**Re: Response to Comments Contact Water Pond 3 (CPW2) Design Report Application for the Hope Bay Project, Type A Water Licence No. 2AM-DOH1335**

<b>Interested Party:</b>	<b>CIRNAC</b>	<b>Rec No.:</b>	<b>CIRNAC-1</b>
<b>Re:</b>	<b>Location of CWP3</b>

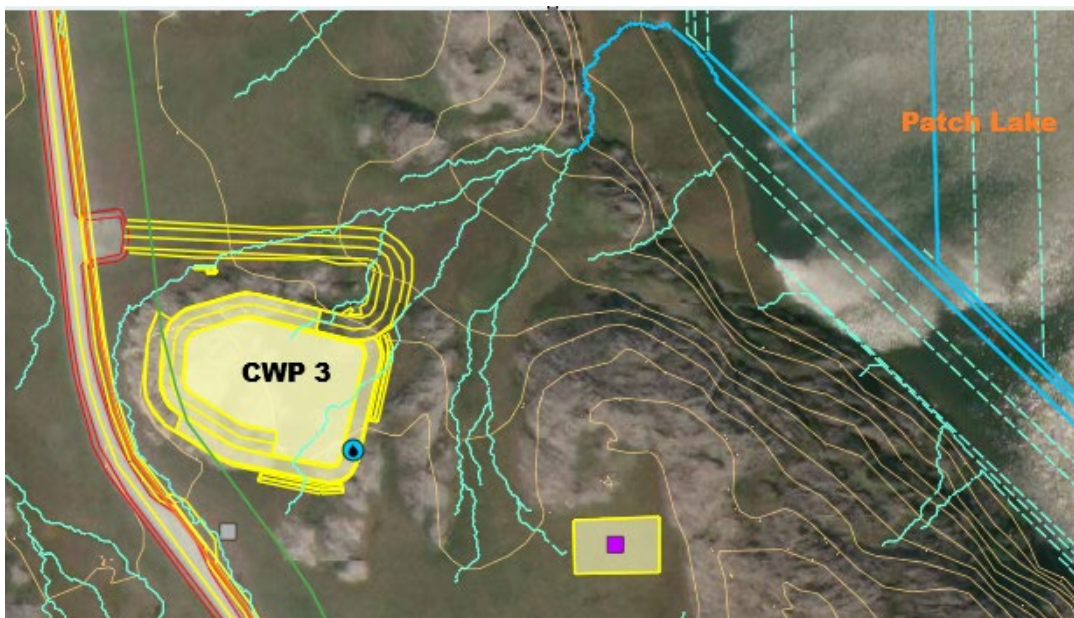
*The application does not state where the CWP3 will be located. The concern is that the CWP3 could be located within 31 meters of the normal high water mark of a water body or that it is outside of the footprint of the Hope Bay Project.*

*CIRNAC recommends that the applicant provide information regarding the proposed location of the CWP3 preferably by photo in relations to other camp structures and water bodies and confirm that it is located within the footprint of the Hope Bay Project a minimum distance of 31 meters of the normal high water mark of a water body.*

CWP3 is within the Project Development Area of the Hope Bay Mine. It is located north of the Naartok portal and to the east side of the Windy Road (all-weather road linking the Doris and Madrid areas). The image below shows the location of CWP3 in relation to lakes and infrastructure. CWP3 is outside 31 metres of the normal high-water mark.
